REZONING: CONDITIONAL REZONING - SOUTHGATE APARTMENTS (P21-62-CZD)

CITY OF HENDERSONVILLE - COMMUNITY DEVELOPMENT STAFF REPORT

View of delivery truck preparing to back in to loading dock at shopping center utilizing proposed driveway to subject property

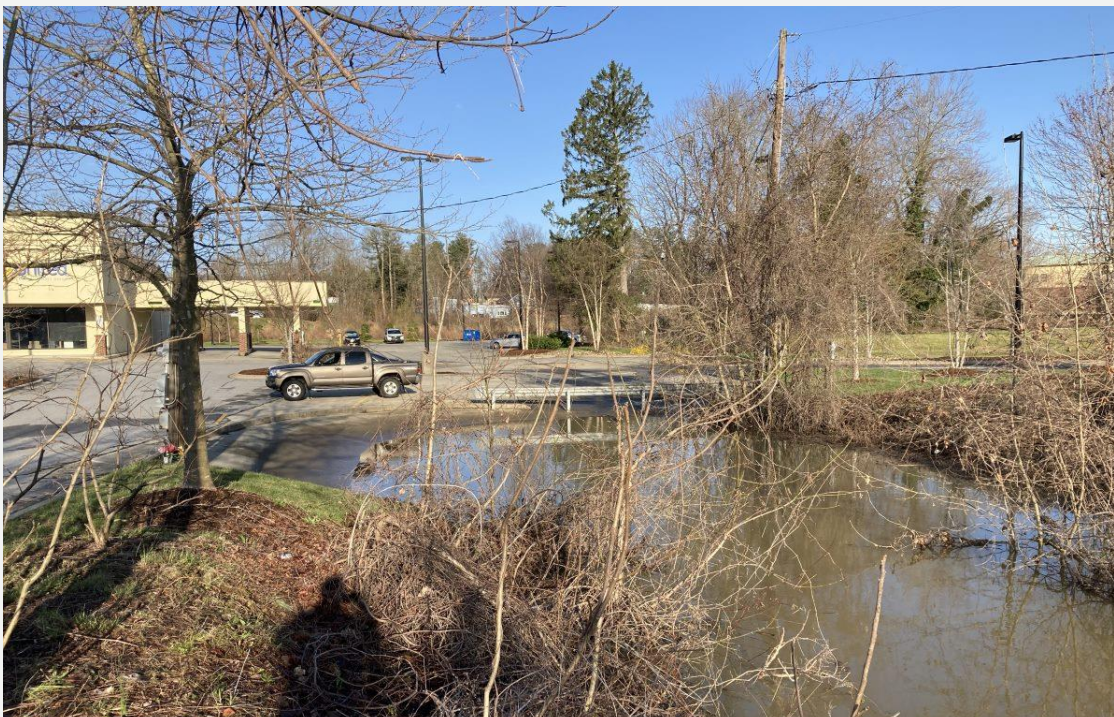
In addition to the requested technical revisions to the report, recommendations related to addressing conflicts with delivery trucks entering the entrance area of the site have been provided to the applicant. The delivery schedule for Southgate is as follows:

- Revise TIA accordingly [developer agreed]
- Revise site plan to accommodate recommended Alternative for entrance / loading dock access. [developer agreed]
